WILDFLOWER COTTAGES AT HAYMEADOW
EAGLE, COLORADO

DATE:
08/01/25 MAJOR
DEVELOPMENT PLAN

SHEET TITLE:
HARDSCAPE
PLAN

LS-101

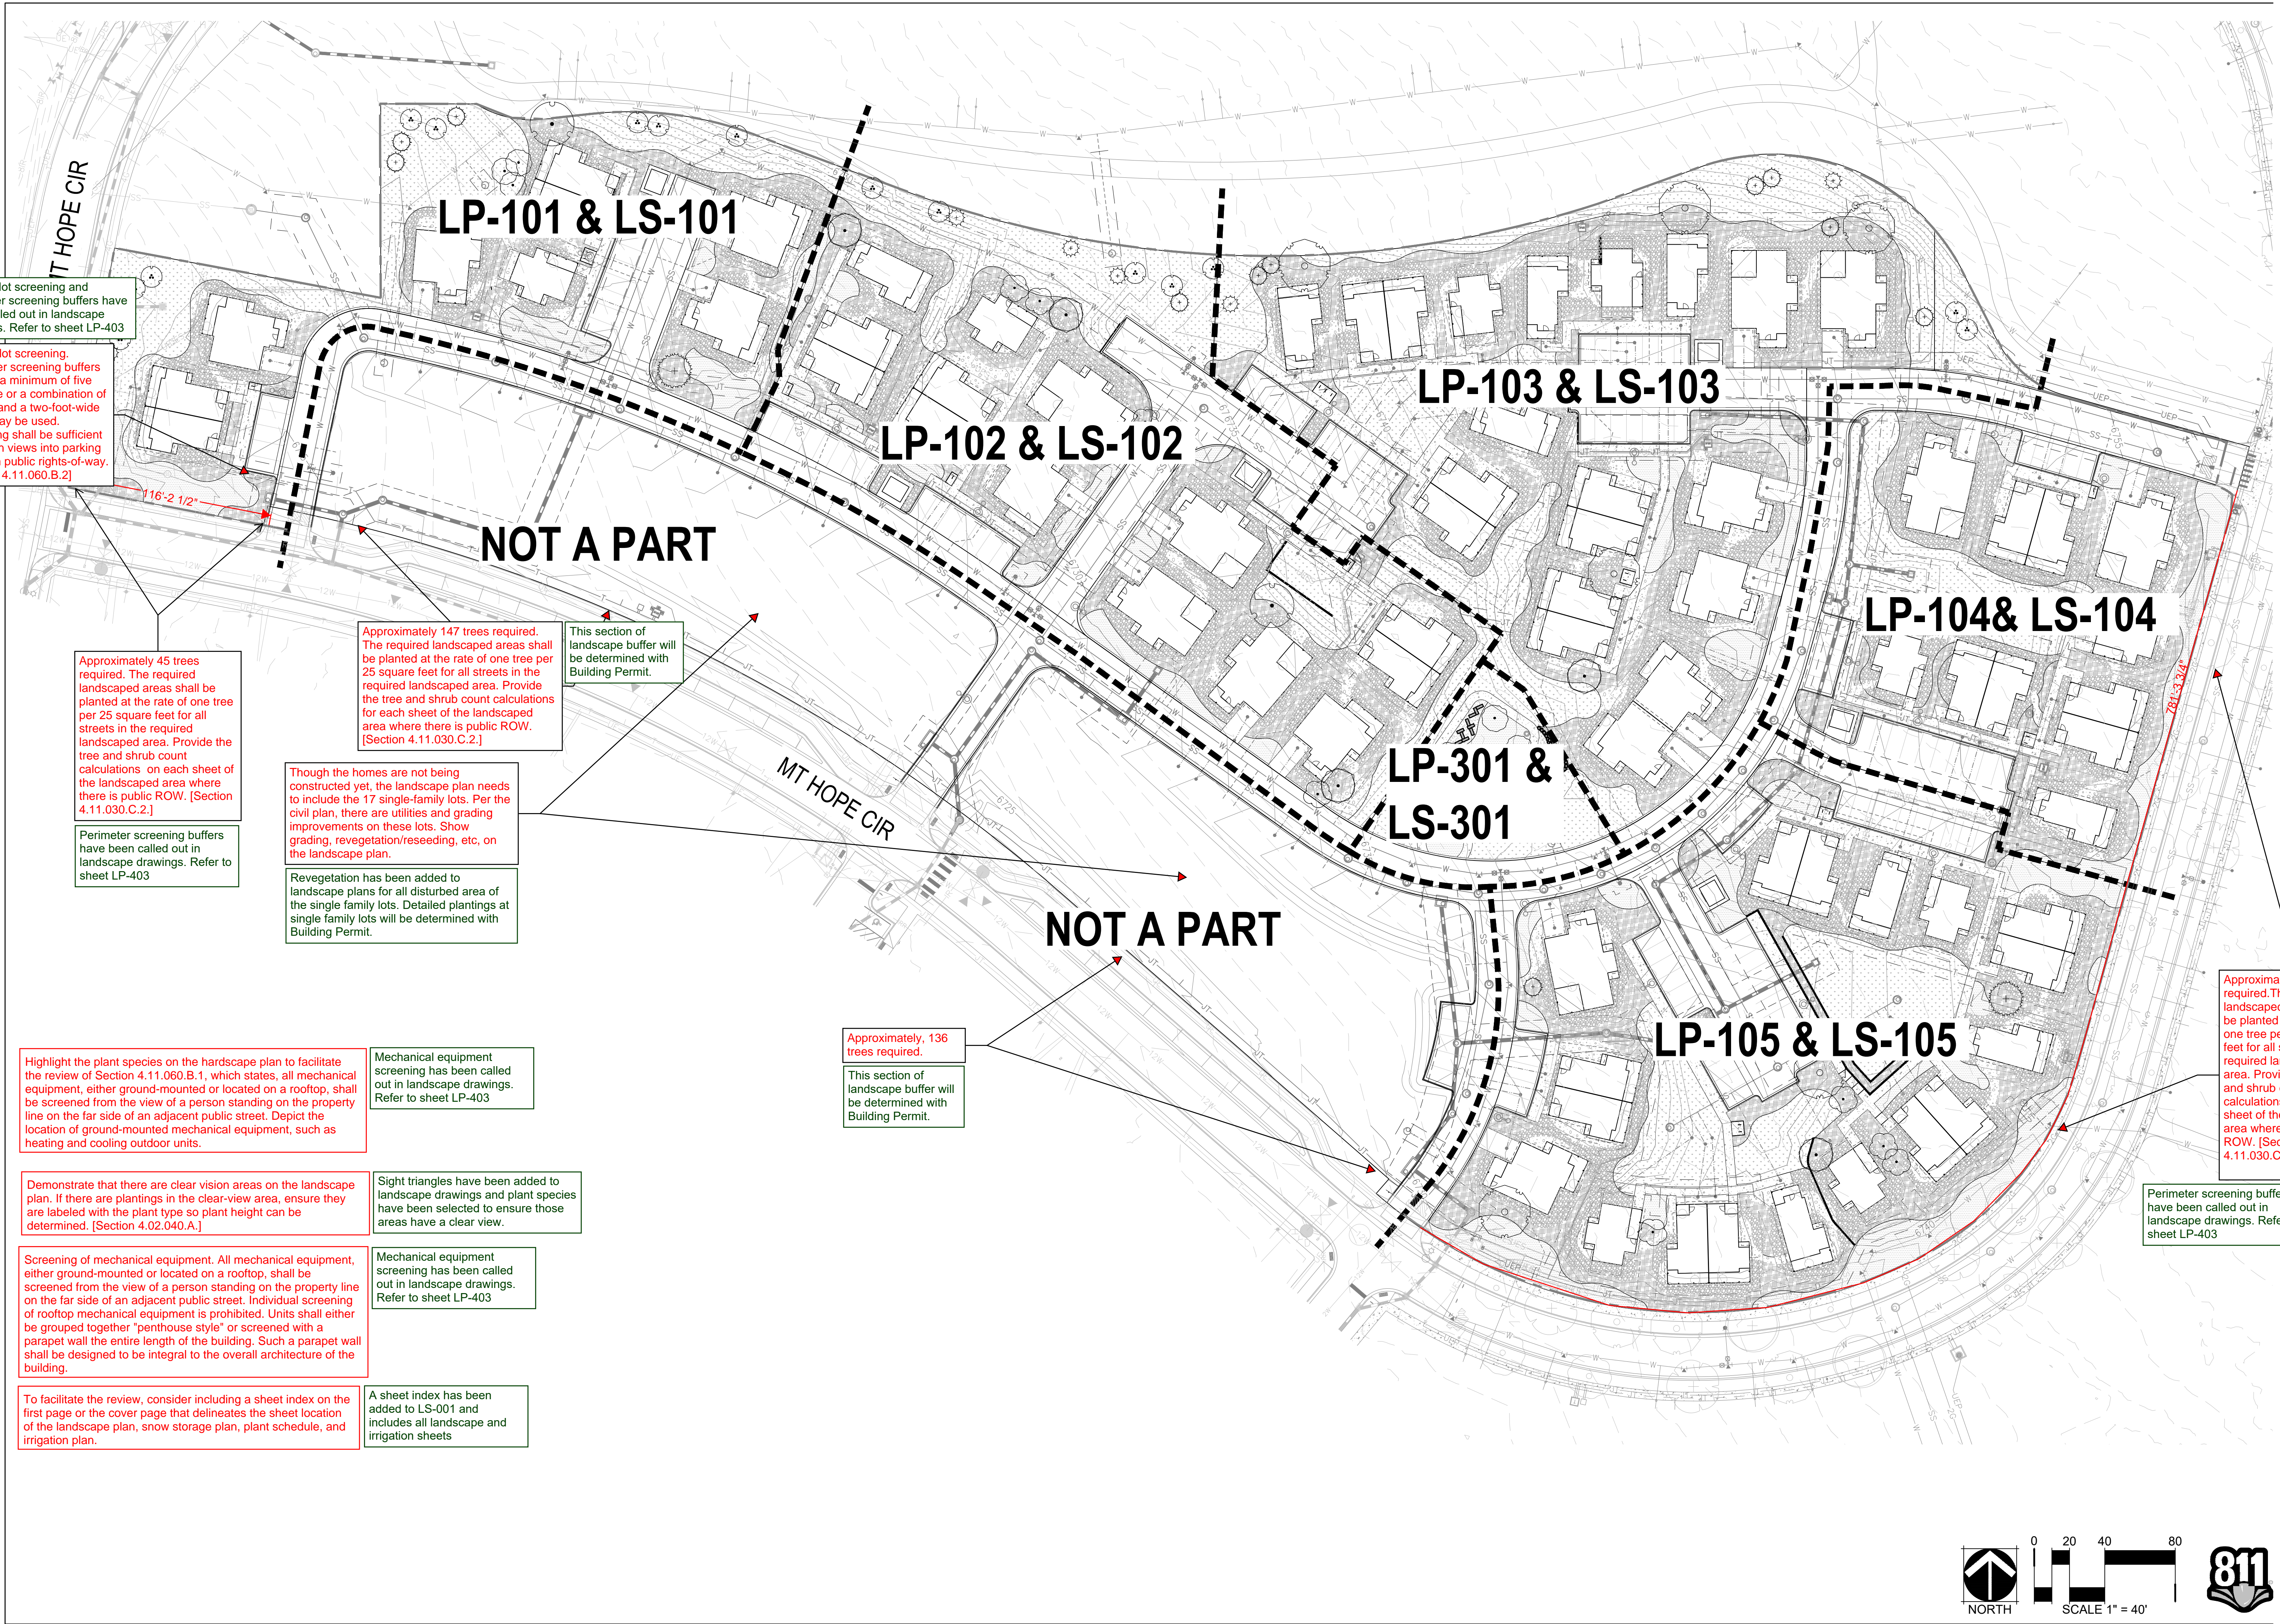
On the plans, note which plants are on the CSU Extension Office Landscape proposals. When using plant materials not on the CSU list, provide information in the plant/landscape notes describing how the proposed plant types are low-water, drought-tolerant, and FireWise. [Section 4.11.030; <https://extension.colostate.edu/resources/firewise-plant-materials/>].

We have been working with an ecologist to finalize a plant list that utilizes a diverse range of species to meet the intent of these requirements. We have added water use, drought-tolerant and Firewise compliance information to the plant schedule.

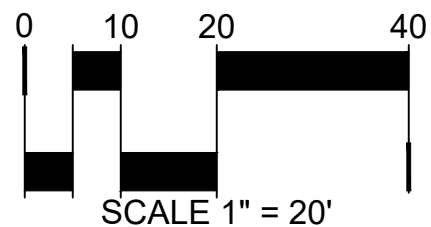
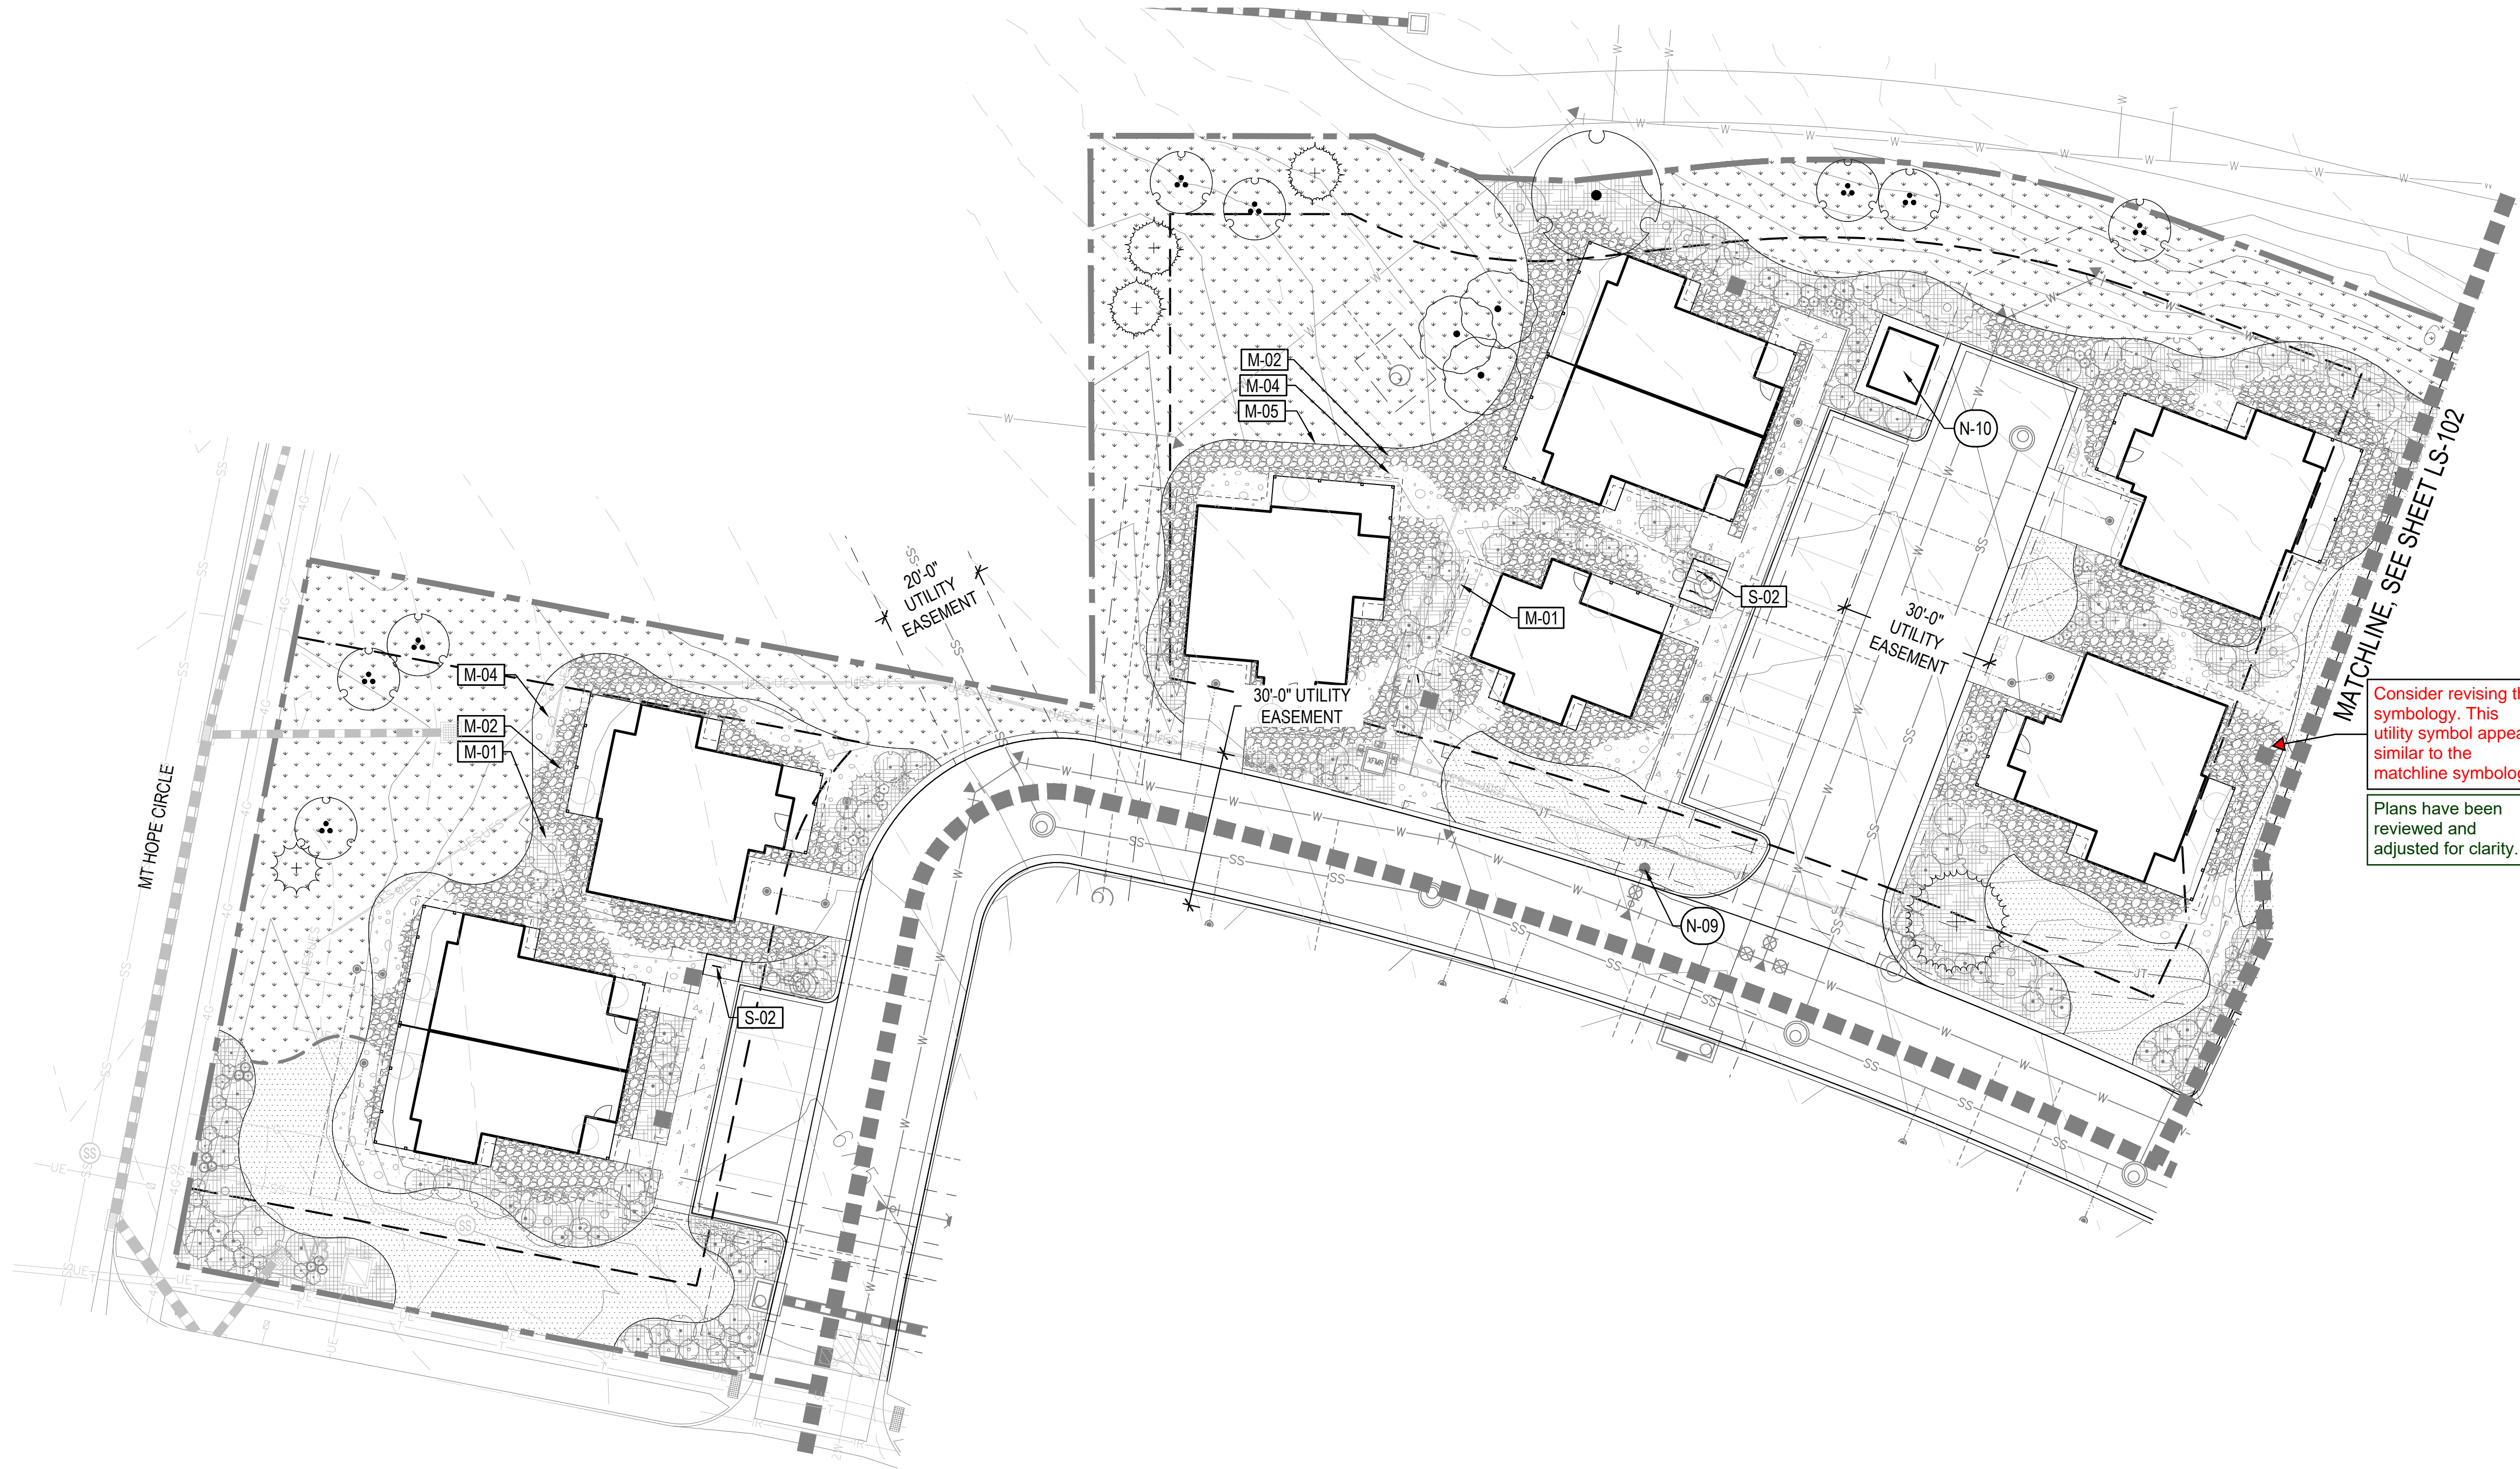
Consider revising the symbology. This utility symbol appears similar to the matchline symbology.

Plans have been reviewed and adjusted for clarity.

SHEET TITLE:
IRRIGATION
PLAN

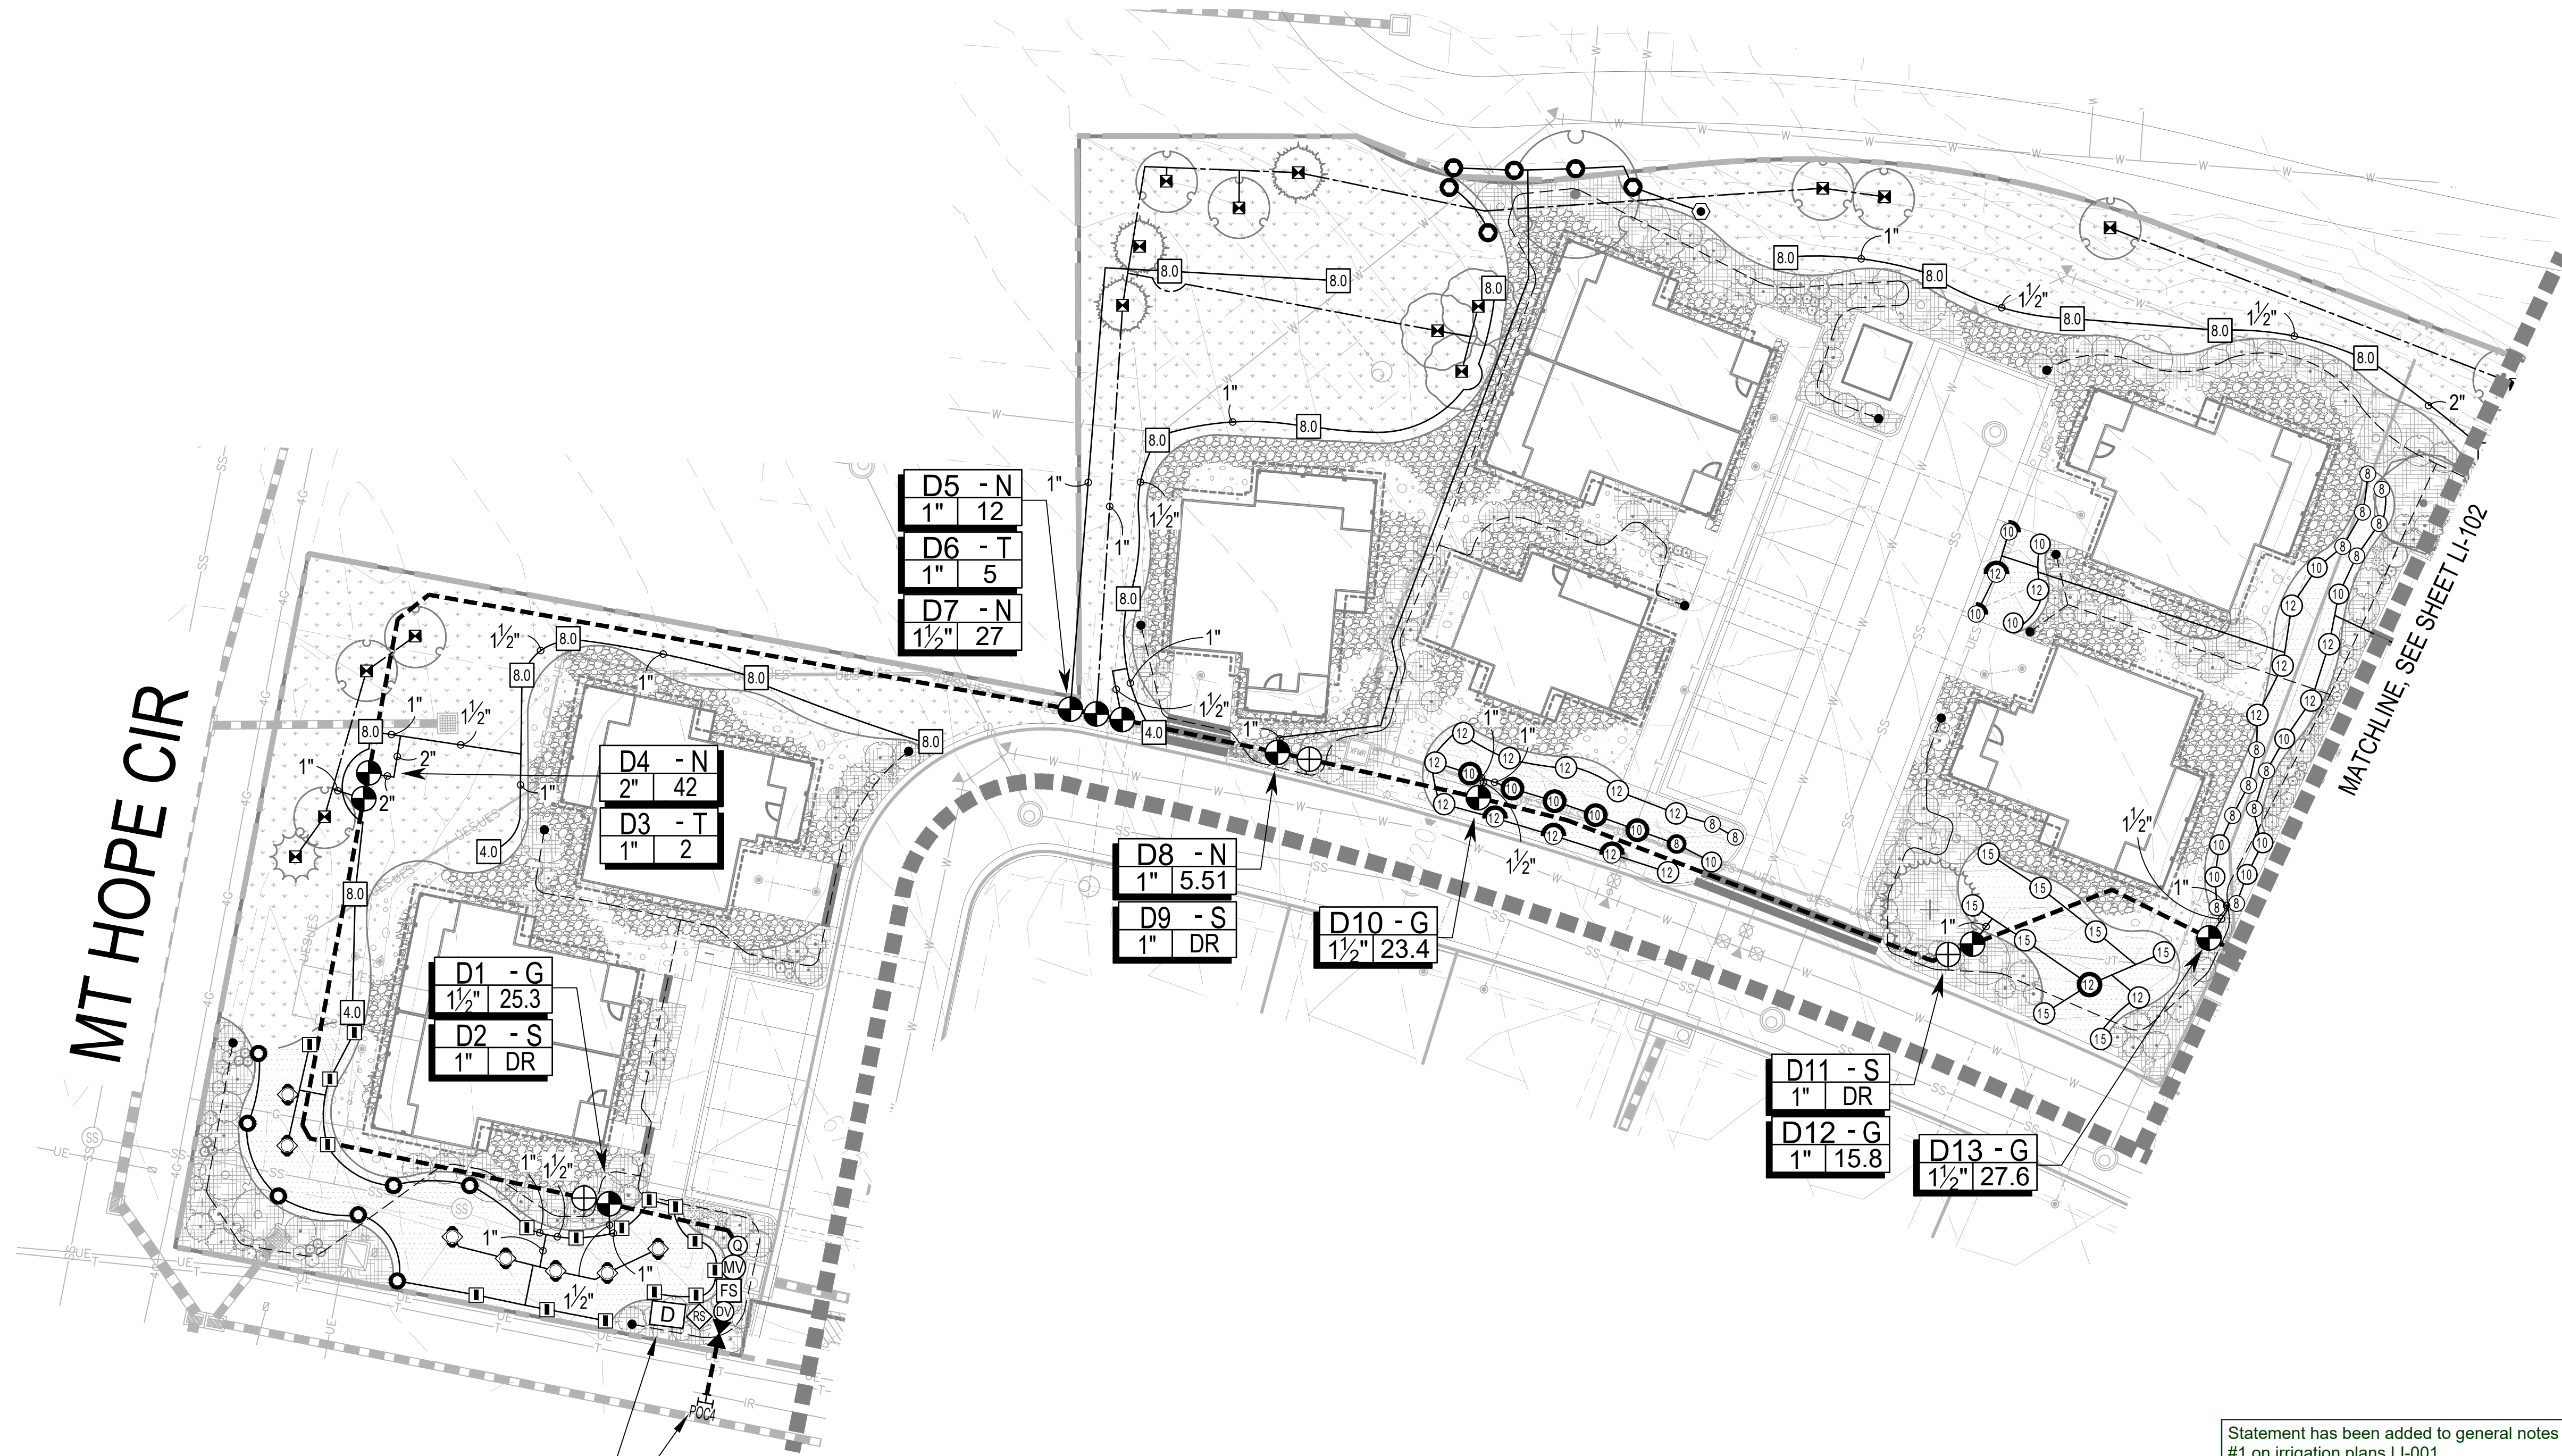
The Haymeadow PUD states, the
Haymeadow Metropolitan District will own and
operate the raw water irrigation system
serving the development. Add this statement
to the landscape plan Key notes and indicate
on the plan that development will utilize a raw
water irrigation system.

Statement has been added to general notes
#1 on irrigation plans LI-001
